VERANDA PARK II RESIDENTIAL

SUMMARY

East/West Drive Aisle proposed between Lot 3 (Building 2000 & 3000) and Lot 2 (future commercial)

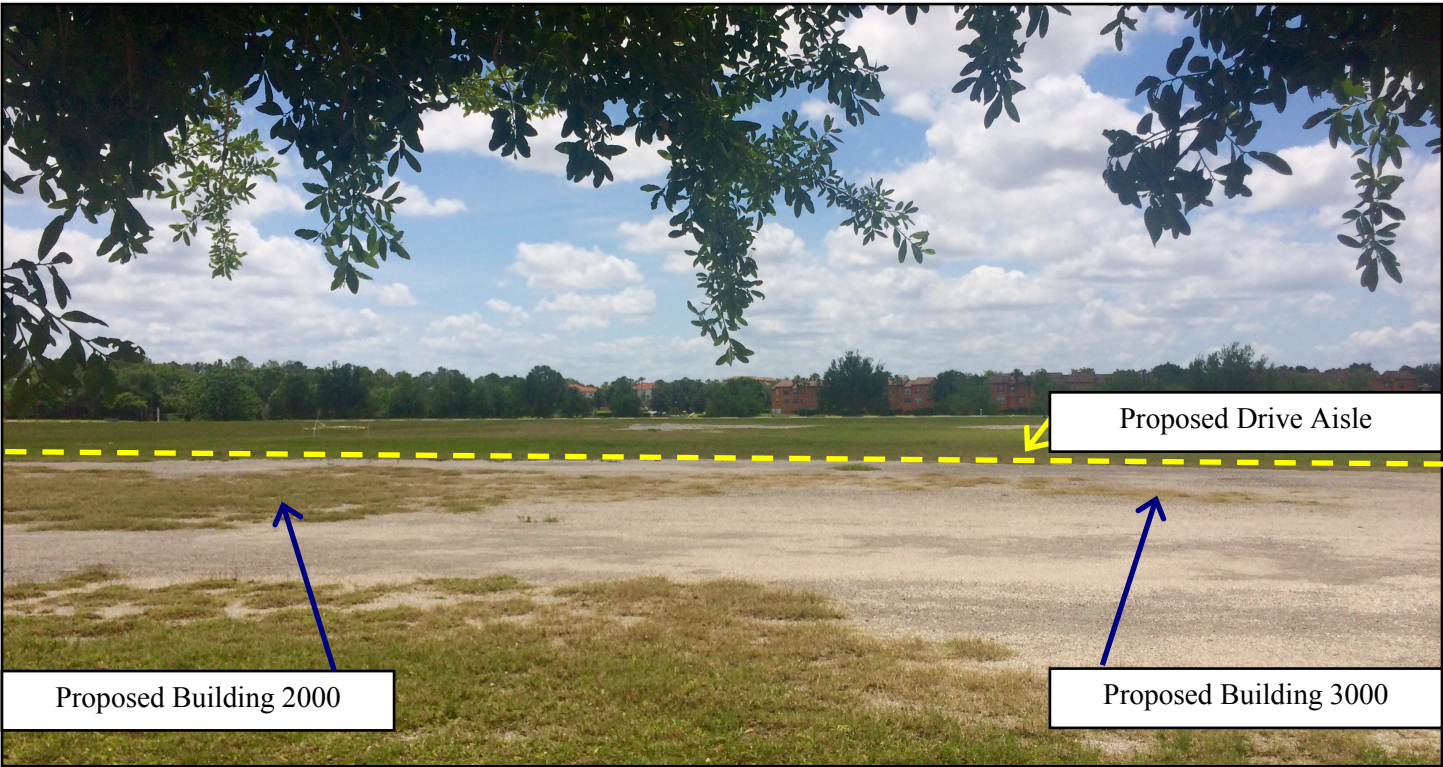
A 24 ft. driveway within a cross-access easement is proposed for future vehicular and pedestrian connections and will be an east west connector between Via Venzano Ave. and Via Arezzo Ave. This driveway will be constructed with the future commercial development, since there are currently adequate pedestrian and vehicular access points to the proposed project. The future driveway will service both the commercial and residential developments. This cross-access easement will include two 12 ft. paved vehicular travel lanes. Head curbs along the paved travel lanes and 6 ft. sidewalks are proposed on each side of the travel lanes within the limits of re-configured Lots 2 and 3.

PROPOSED PHASING PLAN & TIMELINE

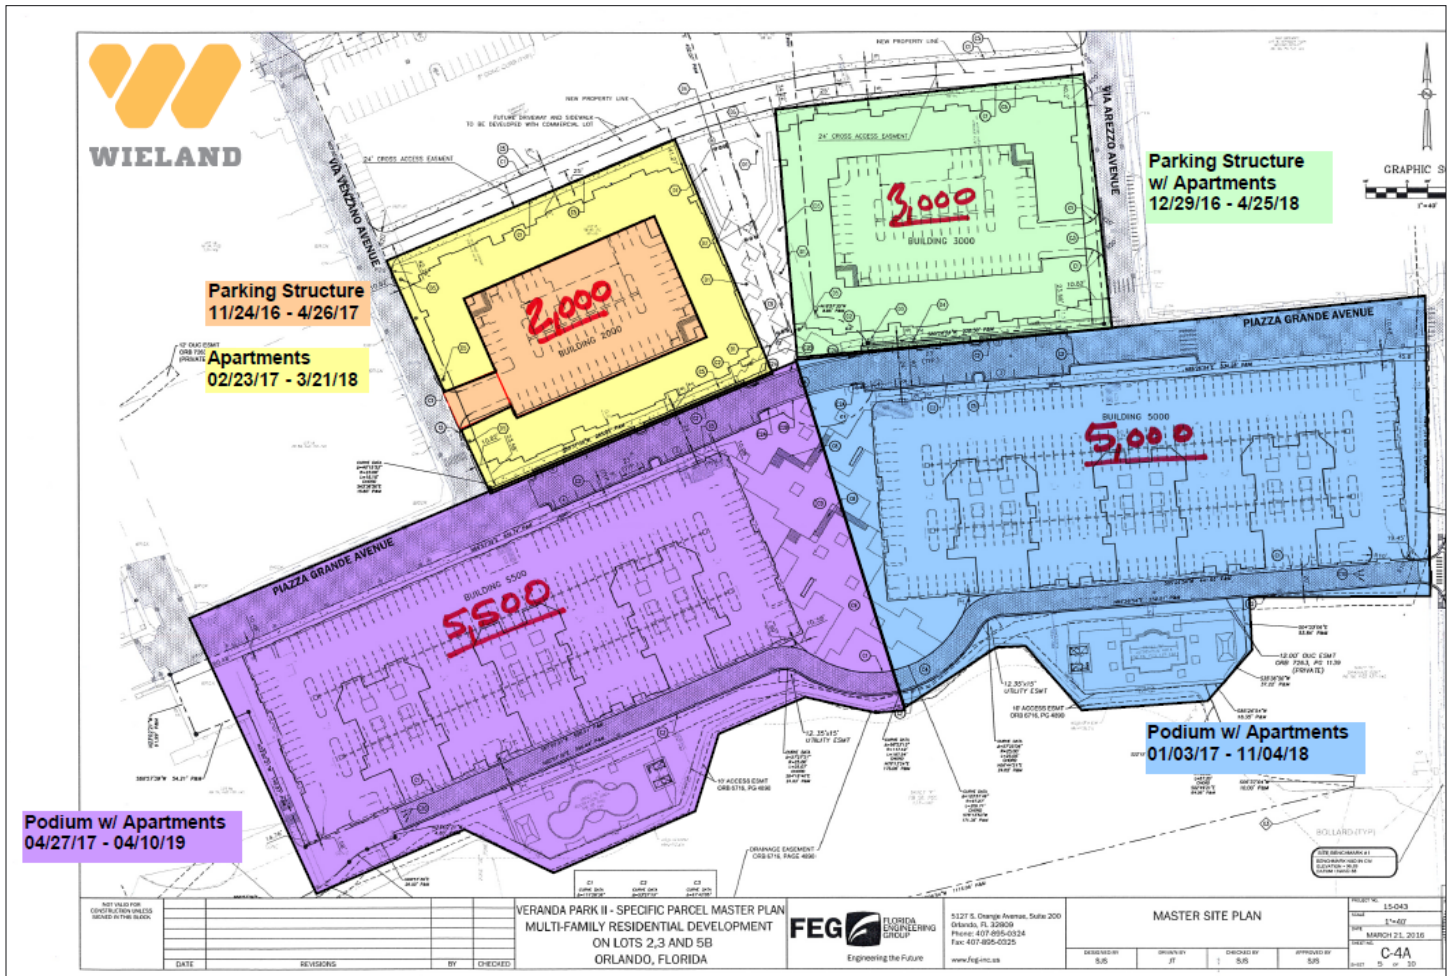
9. Pedestrian Path. Provide stamped concrete, pavers, or an alternative material treatment with a smooth surface for all pedestrian crosswalks.
10. Phasing. Phase 1 shall follow the general timeline provided by the applicant on page 19 of this report. Some flexibility may be granted by the Zoning Official. The subject site shall host sufficient parking spaces at each phase of development. Phase 2 will be reviewed as an SPMP following the approval of this application.
